PRODUCT CHANGE NOTICE

PCN # USB1115 B PCN  
20150812

Drawing Revision Letter: B

USB1115-30-A

**Description of Changes**

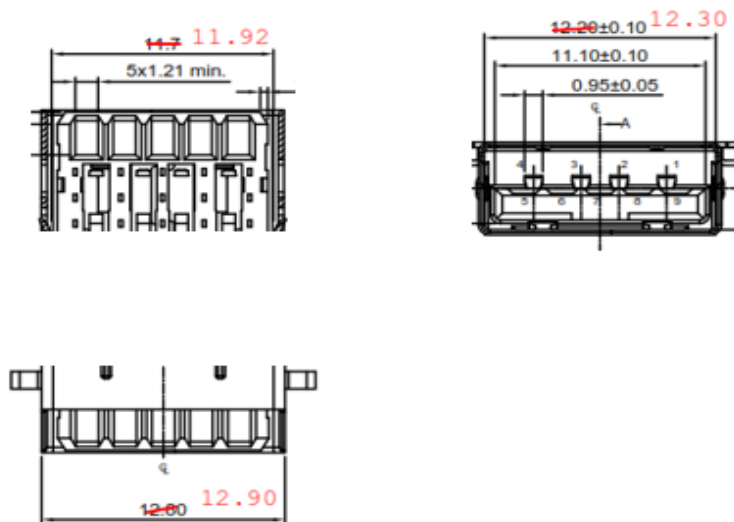
1. Dimension change from 11.7 to 11.92mm
2. Dimension change from  $12.20 \pm 0.10$  to  $12.30 \pm 0.10$ mm
3. Dimension change from 12.80 to 12.90mm
